Item 4.**Development Application 98-106 Kippax Street, Surry Hills - D/2025/758****File Number:** D/2025/758**Summary**

Date of Submission:	18 August 2025 Final amended plans received on 16 March, 2026
Applicant:	Joshua Brandon
Architect/Designer:	DKO Architecture
Owner:	Isaac Solomon, Sara Cooper and Elizabeth Oxman
Planning Consultant:	The Planning Studio
Heritage Consultant:	NBRS and Partners
Cost of Works:	\$27,804,746.79
Zoning:	The site is located within the MU1 - Mixed Use zone. The use is defined as a "residential flat building", with "retail premises", and is permissible with consent within the zone.
Proposal Summary:	Approval is sought for the substantial demolition of the existing building, retention of some built form elements including a former horse stables, and construction of an 8-storey mixed-use development comprising retail tenancies on the lower levels, basement carparking, 42 residential apartments with affordable housing units and associated rooftop common open space and landscaping. The application is being reported to the Local Planning Panel for determination as the development is for a new residential flat building and does not comply with the minimum car

Figure 29: 3D perspective of the proposal showing a comparison with the height of surrounding development

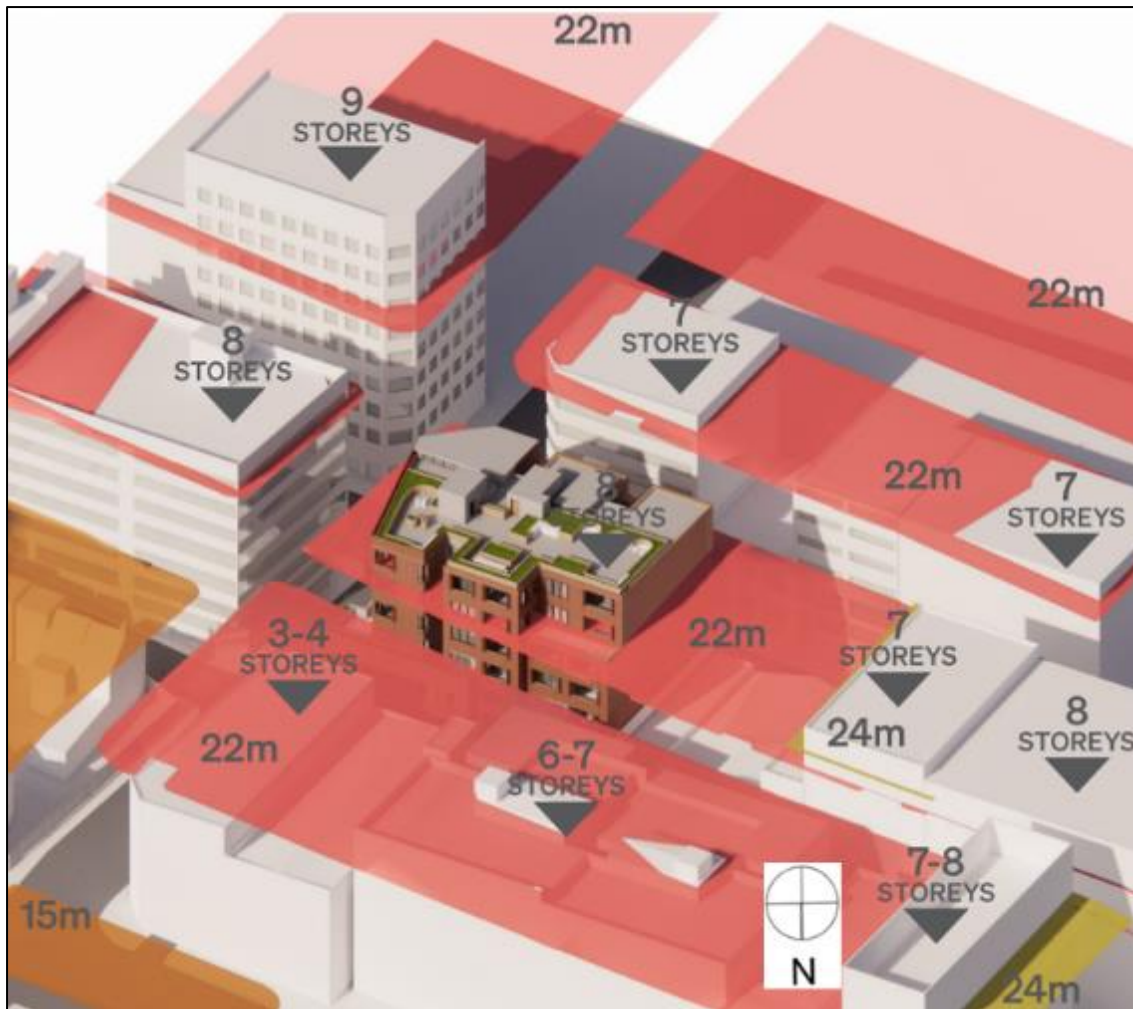
- (a) The height of the proposal is appropriate within the context of the site and surrounding development (including the eight storey commercial building at No.110-120 Kippax Street directly to the east, and the nine storey mixed-use building at No.14 Waterloo Street directly to the south-east) which generally varies in height between 3-9 storeys as shown in the below figure.

Figure 30: Rooftop landscaping as per the submitted Landscape Plans prepared by DKO Landscape

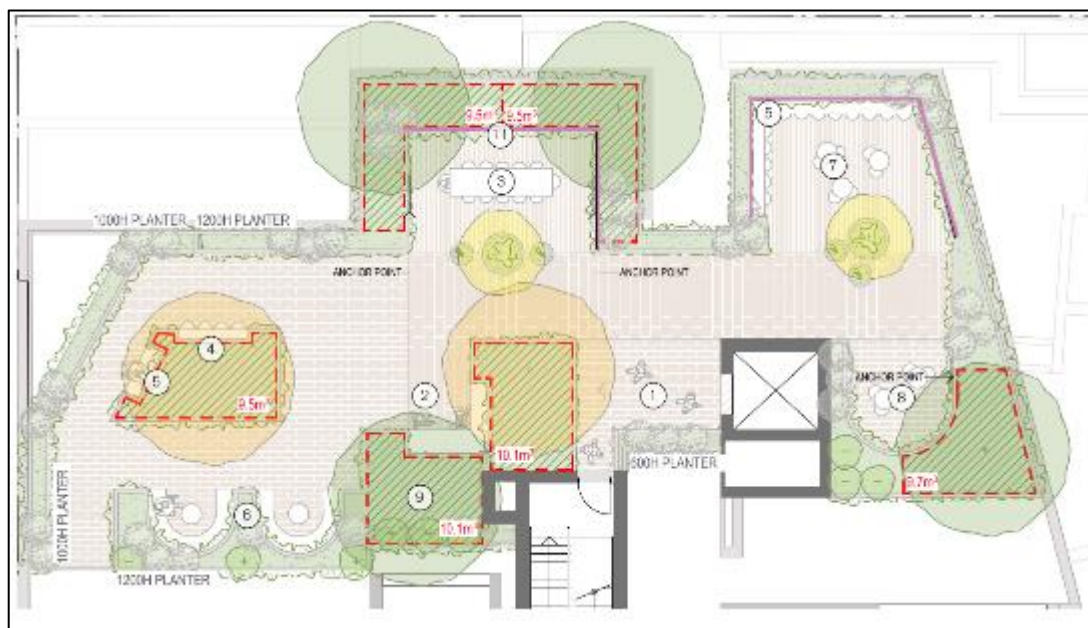
81. Although the proposal provides 129.1 sqm of landscaping on structures, given that definition for landscaped area under the SEPP Housing excludes the area of the site occupied by a building, none of the proposed landscaping meets the definition of landscaped area, and therefore the proposal provides nil landscaped area, which results in a variation of 100%. The majority of landscaping on site is provided within the rooftop communal terrace with additional planters provided adjacent private balconies on Levels 1, 2, 3 and 4, as shown in the below figures.

Figure 37: Cross-ventilation diagram from the submitted design report illustrating natural air flow through the breezeway

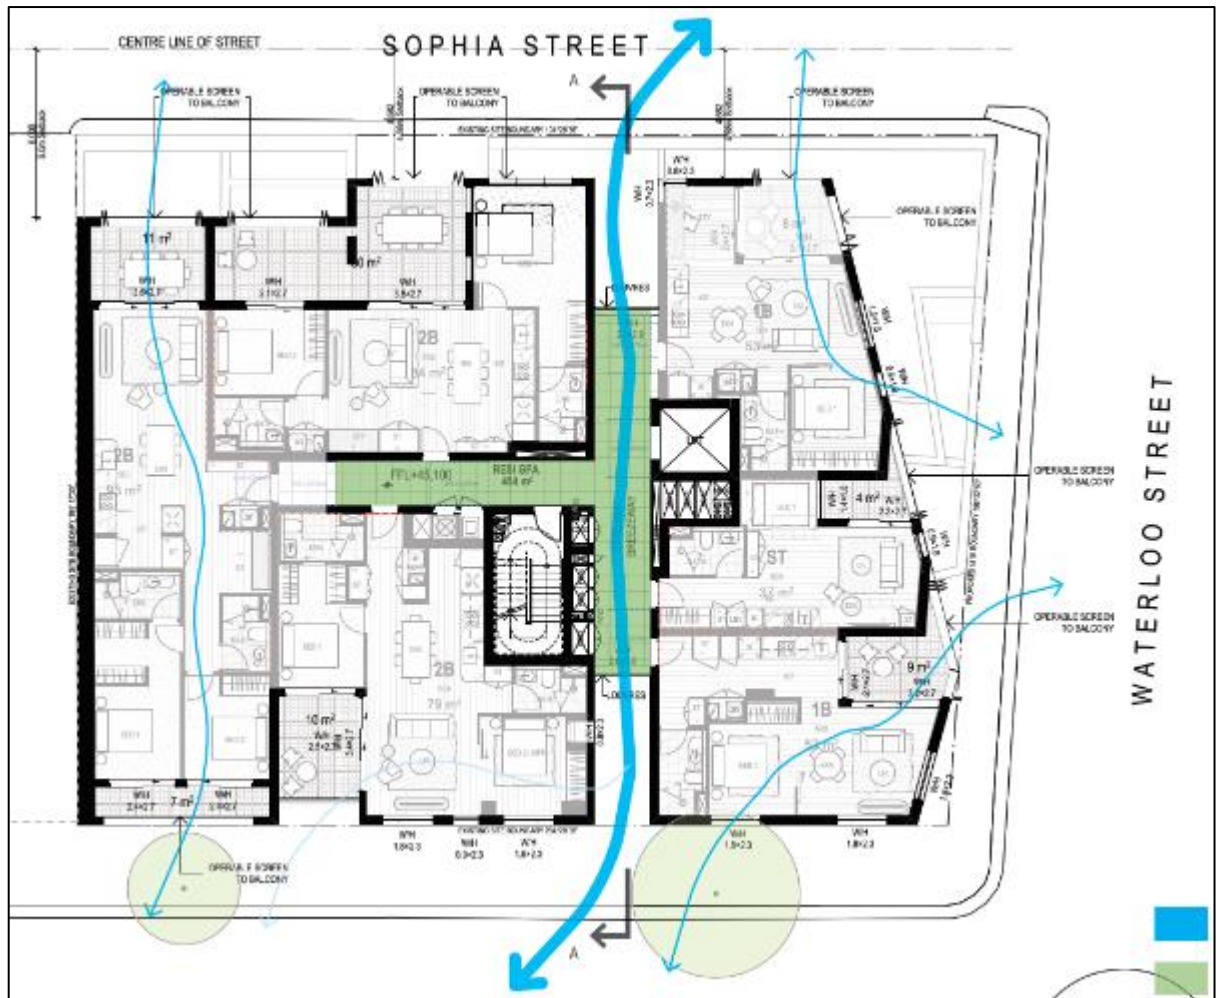
101. The submitted drawings indicate that 50% of the apartments (21 units) are naturally cross-ventilated, noting that the single aspect Unit 703 on Level 7 incorporates an operable roof window to achieve cross ventilation. The proposal also incorporates a north-south breezeway to provide additional ventilation to five of the south facing single aspect apartments. While reliance on the breezeway for the single aspect apartment does not strictly meet the ADG definition of cross-ventilation it is considered suitable as a secondary measure to assist in providing adequate natural ventilation through the apartments. The use of the breezeway for additional ventilation is depicted in the below figure.

102. Given that Council is supportive of retaining original fabric and features of the stables building as well as providing an affordable housing component, achieving natural cross-ventilation to 50% of apartments with the breezeway providing cross-ventilation to an additional 5 apartments (for a total 62% of apartments receiving cross-ventilation) is considered an acceptable outcome, and is considered to meet the objective 4B-3 of the ADG, which is to maximize cross-ventilation to create a comfortable indoor environment for residents.

Figure 38: Claimed cross-ventilation through Unit 602

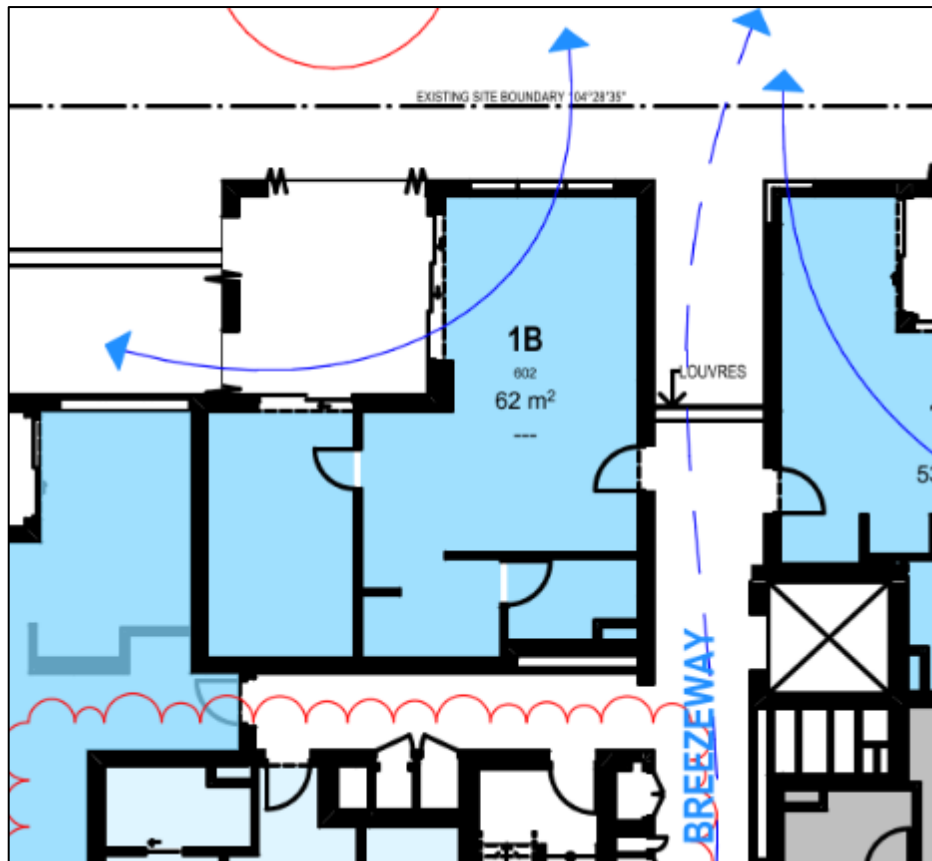
103. However, it is noted that the north facing Unit 602 is claimed to achieve natural cross-ventilation, however the submitted cross-ventilation diagram shows the air flow only travels through the north-western corner of the living room (less than 50% of the living area), and as such this unit does not appear to be strictly cross-ventilated as shown in the below figure.

104. Therefore, a condition of consent is recommended for Unit 602 to incorporate an operable fanlight above the entrance door to provide additional cross-ventilation through the breezeway.

Figure 39: Cross-section through the Sophia Street interface

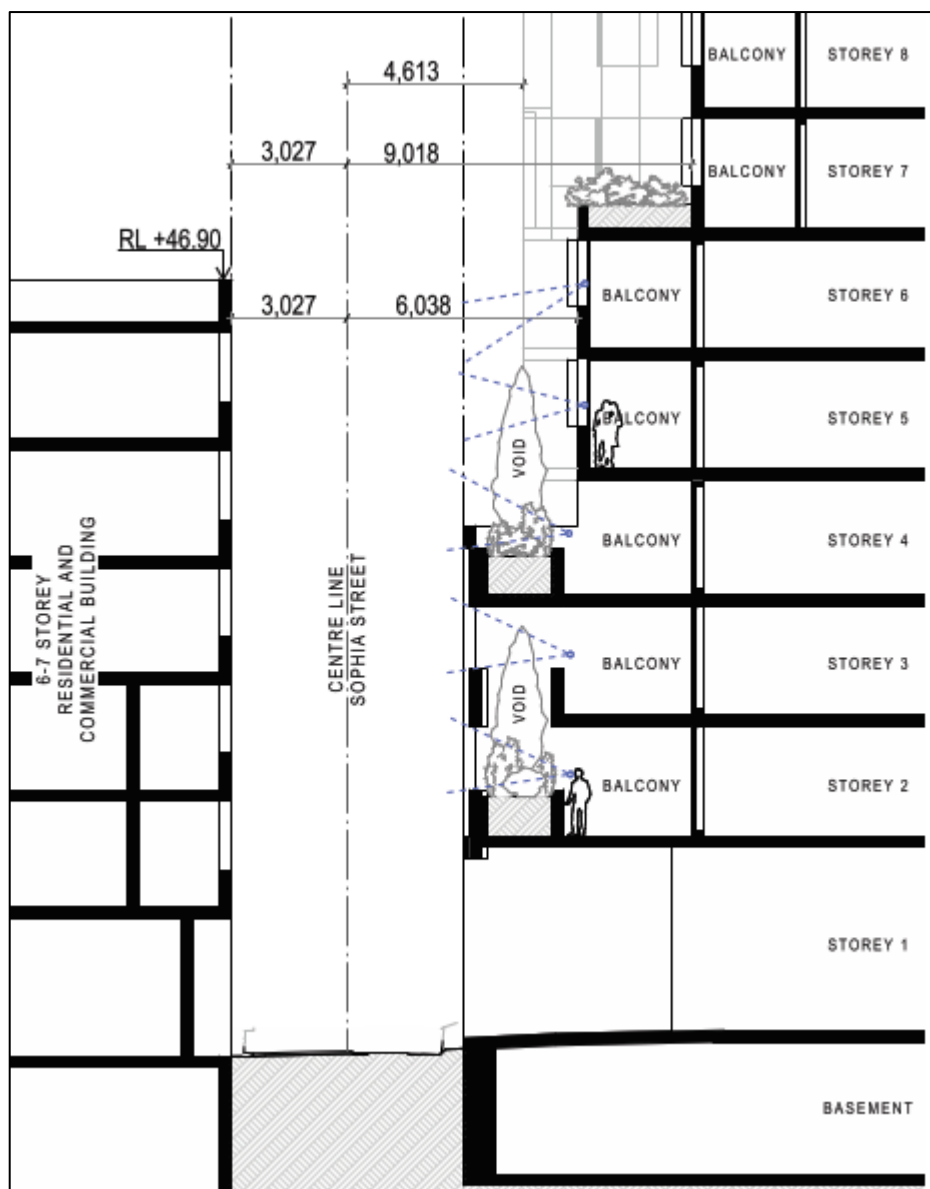
108. For the Sophia Street (northern) frontage, the proposed development utilises a number of additional measures to mitigate visual privacy impacts, including solid balustrades and planters to balconies, and a stepped facade with increasing setbacks to upper levels along Sophia Street as illustrated in the below figure. It is also noted that the residential apartment building on the opposite side of Sophia Street (No. 81 Foveaux Street) features a nil setback to Sophia Street.

Figure 41: The proposed awning as depicted in side elevation and in cross-section

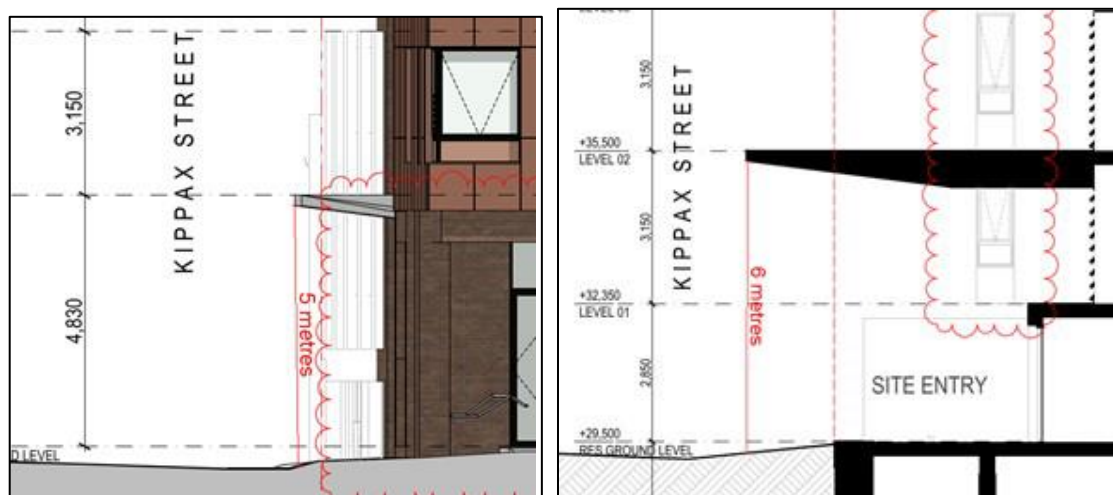
113. The existing building does not feature any footpath awnings and none of the street frontages are identified as requiring footpath awnings or colonnades. The proposal includes a fixed awning over the entrance to the residential lobby along Kippax Street.
114. The architectural drawings indicate that the proposed awning is at Level 2 (RL 35.5), which due to the slope of the site along Kippax Street would place the awning at a height of between 5-6m above the footpath. This would not provide effective weather protection to the lobby entrance, and does not comply with the DCP controls which requires that footpath awnings are to be between ground and first floor levels between 3.2-4.2m above the footpath.

Figure 42: Location of the proposed entrance awning relative to the footpath on the Kippax St (south) elevation

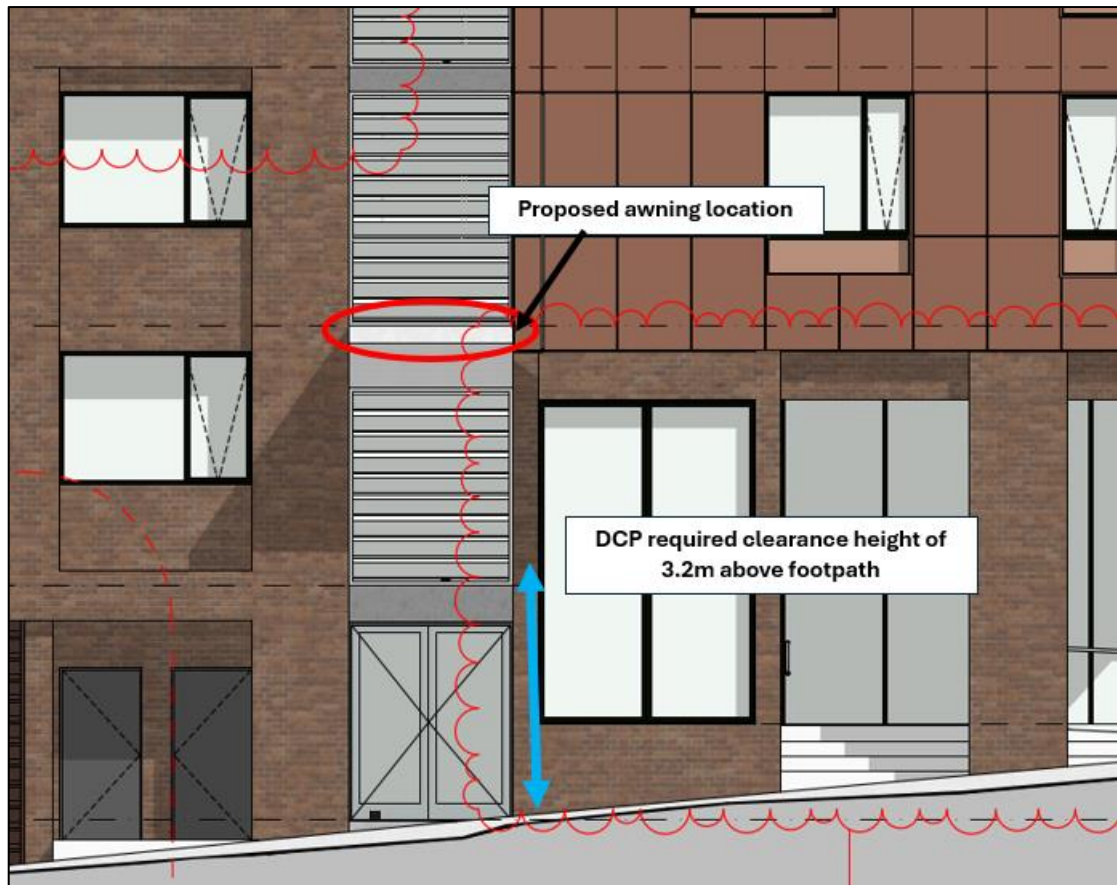
115. It is also noted that lowering the awning to be comply with DCP controls (3.2-4.2m) would likely require substantial pruning of the nearby street tree, and Council's Tree Management Officer advised that based on measurements taken on-site, and the submitted pruning schedule, the extent of pruning required would result in the loss of a significant branch which would impact on the viability of the street tree.

Figure 44: View lines from 110-120 Kippax Street and 81 Foveaux Street across the subject site

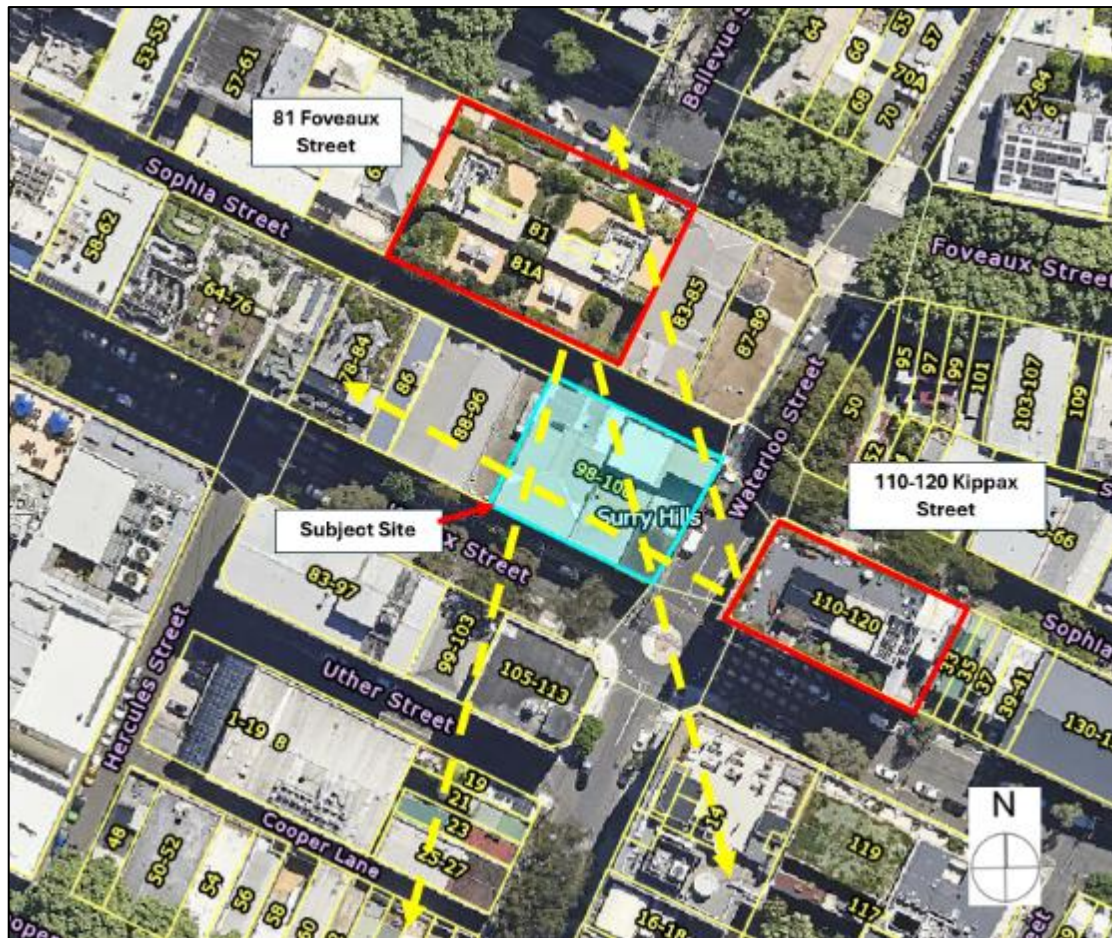
117. View loss and impacts to outlook have been raised as an issue within public submissions received following the notification of the proposal to neighbouring properties. The applicant has submitted a view analysis conducted from the commercial building at No.110-201 Kippax Street directly to the east, and from Level 4 apartments at No.81 Foveaux Street directly to the north-west. The submitted view analysis has been verified by Council's Model Team against the submitted 3D model.
